## Service Bulletin

SEB07-3

MAIN LANDING GEAR ACTUATOR HYDRAULIC LINES INSPECTION

Figure 1. MLG Actuator Hydraulic Lines Inspection (Sheet 1)

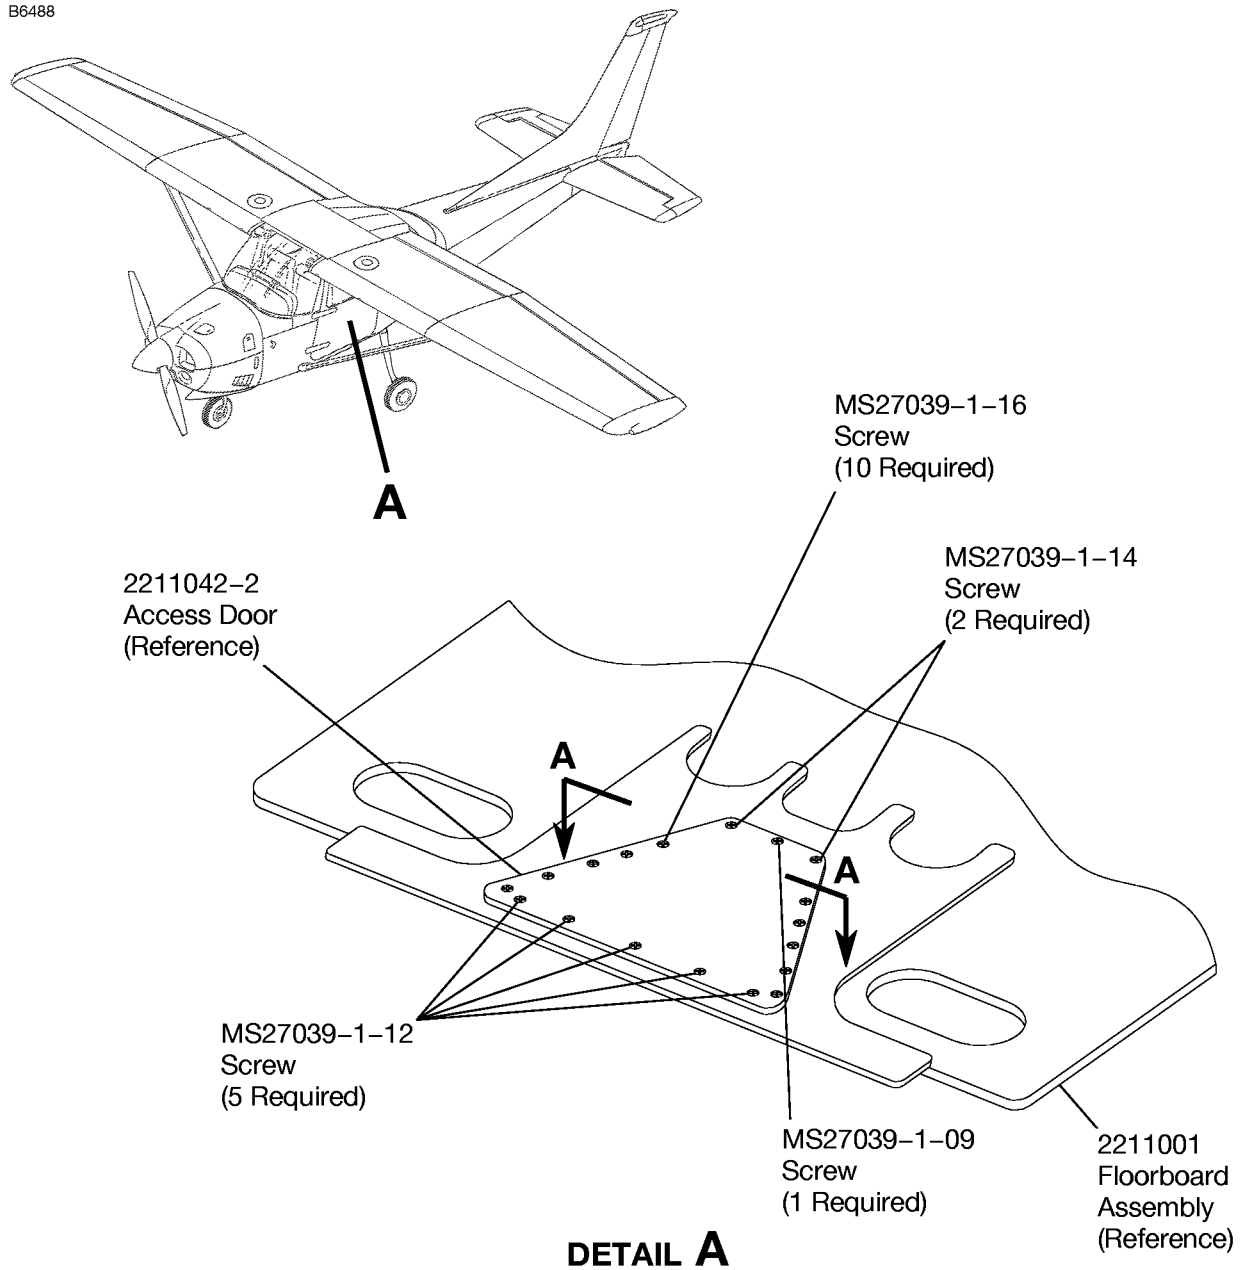
**NOTE:** If an installed screw is more than the length specified in the applicable illustrated parts catalog or in Figure 1, Detail A, there can be damage to the hydraulic lines near to the screw.
  - B. Remove the 2211042-2 Access Door. Keep the screws.
5. Do an inspection of the hydraulic lines.
  - A. (Refer to Figure 1, View A-A and Detail B.) Do an inspection of the 2280001-1 (or 2282001-35) Right MLG Hydraulic-Actuator Down Line, 2280001-12 Left MLG Hydraulic-Actuator Up Line, 2280001-11 Right MLG Hydraulic-Actuator Up Line, and 2280001-2 Left MLG Hydraulic-Actuator Down Line.

9. (Refer to Figure 1, Detail A.) Install the 2211042-2 Access Door for the actuator-inspection access panel as follows:
- A. If the kept screws are the correct length and they are in good condition, install the 2211042-2 Access Door with the kept screws. Make sure that you install screws of the correct lengths in the positions shown in Figure 1, Detail A.

- B. If the kept screws are not the correct length or they are not in good condition, install the 2211042-2 Access Door with one MS27039-1-09 Screw, five MS27039-1-12 Screws, two MS27039-1-14 Screws, and ten MS27039-1-16 Screws. Make sure that you install the screws in the positions shown in Figure 1, Detail A.
10. With the kept bolts, install the rear seats. (Refer to the Model R182 and R182 Series 1978 thru 1986 Service Manual.)
  11. Install the carpet in the area of the 2211042-2 Access Door, as necessary.
  12. Remove maintenance warning tags and connect the airplane battery.
  13. Make an entry in the airplane logbook that states compliance and method of compliance with this Service Bulletin.

MS27039-1 Dash Number	Length in Inches (Grip Plus Thread Length)
-09	0.594
-12	0.781
-14	0.906
-16	1.031

Figure 1. MLG Actuator Hydraulic Lines Inspection (Sheet 2)

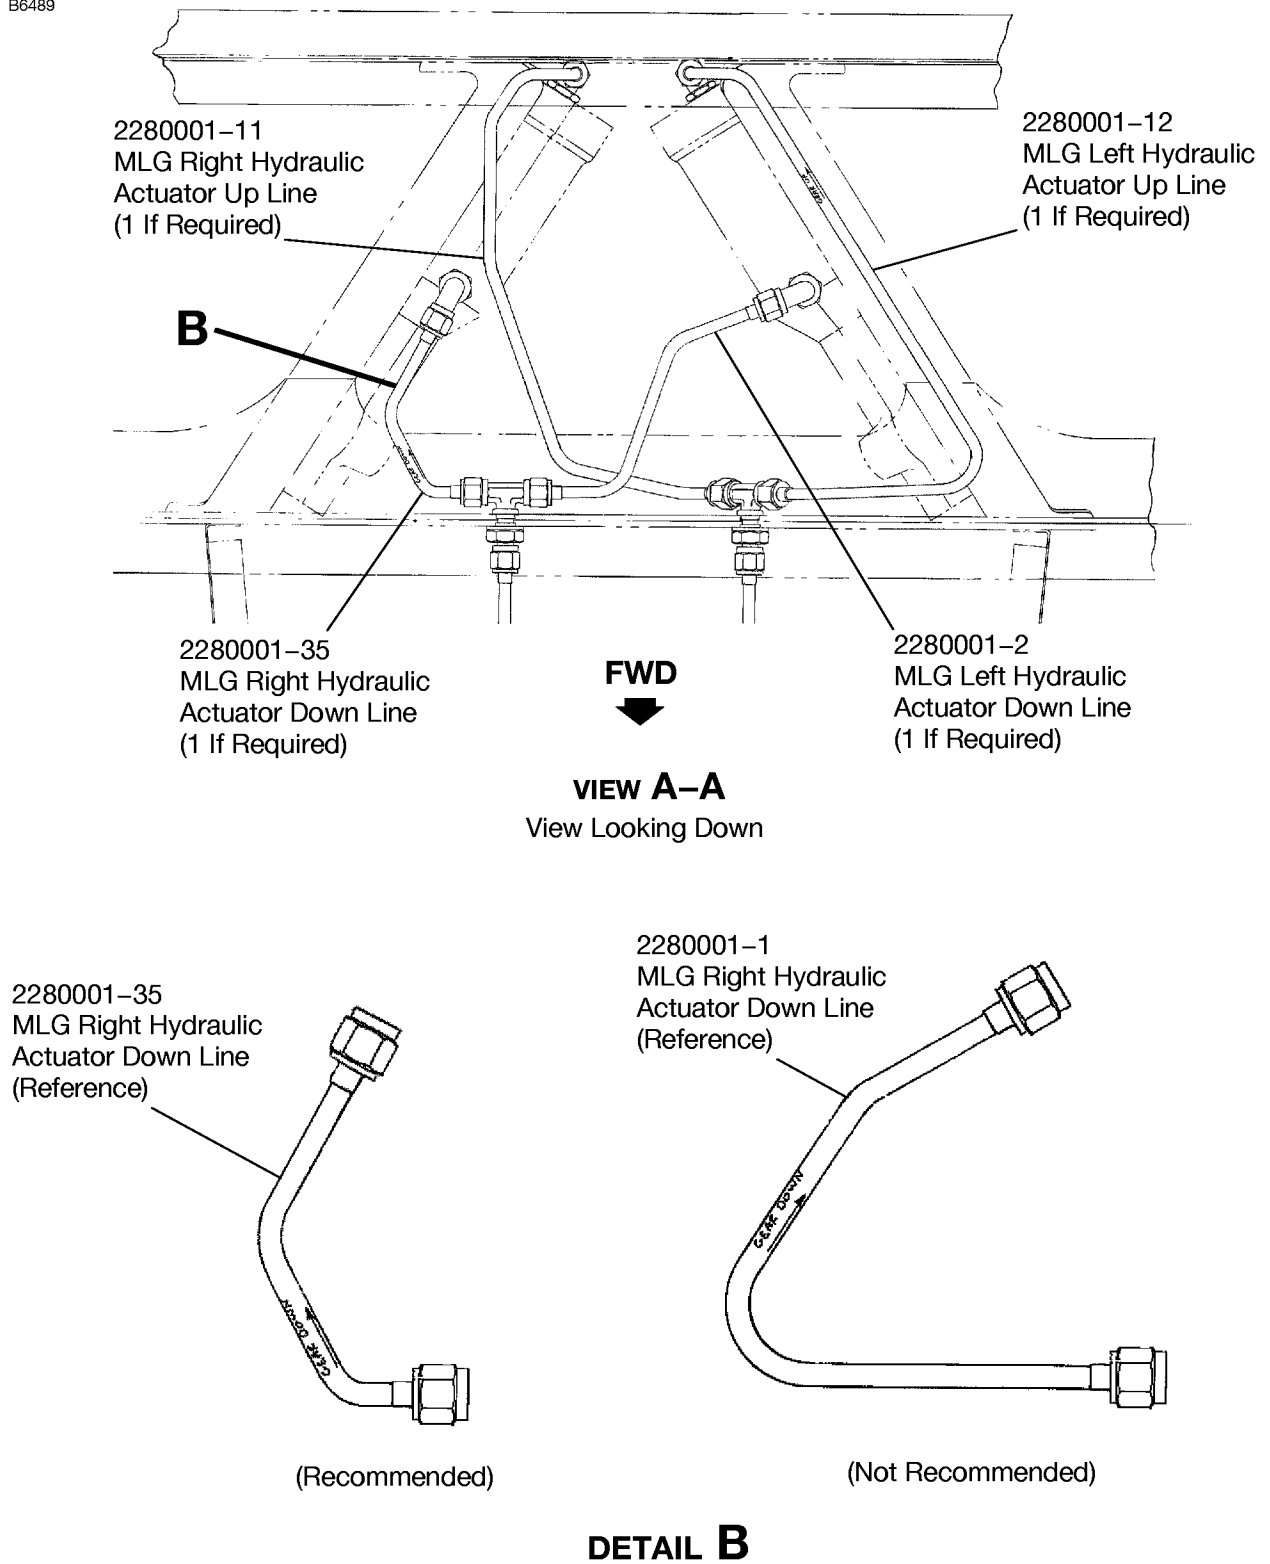
**NOTE:** Although you must examine all of the hydraulic lines that you can see after you remove the 2211042-2 Access Door, you must look closely at the 2280001-1 (or 2282001-35) Right MLG Hydraulic-Actuator Down Line, as it is the line nearest to the screws that install the 2211042-2 Door.

- (1) If no hydraulic lines are damaged and the right MLG hydraulic-actuator down line is the recommended 2280001-35 Right MLG Hydraulic-Actuator Down Line configuration (2280001-35 in Figure 1, Detail B shows the recommended configuration for the hydraulic line), make sure the 2280001-35 part number is legible. If it is not legible, write the part number 2280001-35 on the line with a permanent marker to identify it as the recommended line. Go to Step 9.

- (2) If one or more of the hydraulic lines are damaged, or if the 2280001-1 Right MLG Hydraulic-Actuator Down Line is not the recommended configuration (2280001-1 in Figure 1, Detail B shows the configuration that is not recommended for the hydraulic line), go to Step 6.

6. If one or more of the hydraulic lines are damaged, or if the 2280001-1 Right MLG Hydraulic-Actuator Down Line is not the recommended configuration (2280001-1 in Figure 1, Detail B shows the configuration that is not recommended for the hydraulic line) replace the hydraulic line(s) as follows:

- C. Install a new 2282001-35 MLG Right Hydraulic-Actuator Down Line, 2280001-12 Left MLG Hydraulic-Actuator Up Line, 2280001-11 Right MLG Hydraulic-Actuator Up Line, or 2280001-2 Left MLG Hydraulic-Actuator Down Line as necessary. Go to Step 7. (Refer to the Model R182 and R182 Series 1978 thru 1986 Illustrated Parts Catalog.)
